# Access Compliance Report

## Public Rights-of-Way

### (Curb Ramps)

Intersection ID: 19908	Main Street: BROWN-GRIER_RD	Cross Street: GALLANT_LN	Location: NE
ADA ID: DDF9D62EDF36	Ramp Type: Directional1	Initial Pass/Fail: Fail	Overall Compliance: No
Severity Score: 12.5			
Codes/Mitigation Info/Possible Solution		Field Measurements/Component Compliance

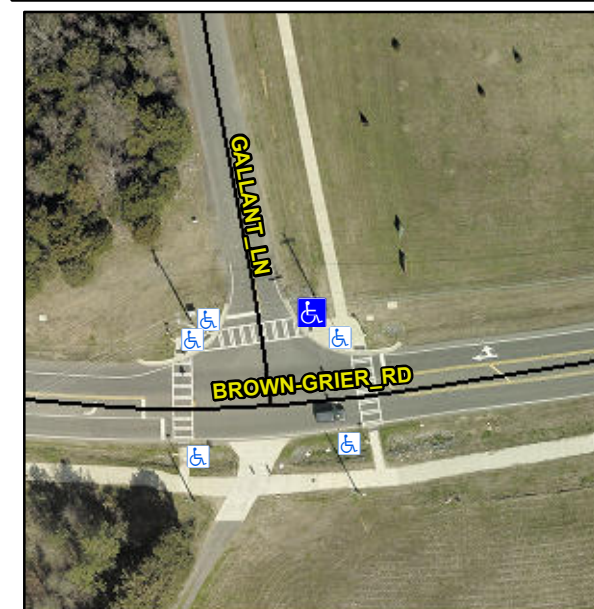
**R304.2.2**

Compliance	Description	Data	Compliance	Description	Data
N/A	Ramp Length (in)	90.0	N/A	Grade Break?	N/A
Yes	Ramp Width (in)	70.0	N/A	Grade Break Slope (%)	0.0
No	Ramp Slope (%)	9.3	N/A	Grade Break XSlope (%)	0.0
Yes	Ramp XSlope (%)	1.2			
N/A	Flare Type LT	N/A	N/A	Flare Type RT	N/A
N/A	Flare Slope LT (%)	N/A	N/A	Flare Slope RT (%)	0.0
N/A	Flare Traversable LT?	N/A	N/A	Flare Traversable RT?	N/A
N/A	Landing Length (in)	0.0	N/A	DWS Provided?	N/A
N/A	Landing Width (in)	0.0	N/A	DWS Contrast?	N/A
N/A	Landing Slope (%)	0.0	N/A	DWS Length (in)	N/A
N/A	Landing X Slope (%)	0.0	N/A	DWS Full Width?	N/A
N/A	Landing Curb? (Y/N)	N/A	N/A	DWS Offset LT (in)	N/A
N/A	Shared Landing?	N/A	N/A	DWS Offset RT (in)	N/A
N/A	Gutter Ponding?	0.0	N/A	Gutter Slope (%)	N/A
N/A	Gutter Lip Ht (in)	0.0	N/A	Gutter X Slope (%)	N/A
N/A	Painted X Walk1?	Yes		Road Slope (%)	2.3
	X Walk 1 Direction	To W		Road X Slope (%)	6.3
	X Walk 1 Width (in)	112.0		Clear Space?	N/A

**Remove & Replace Entire Ramp.**
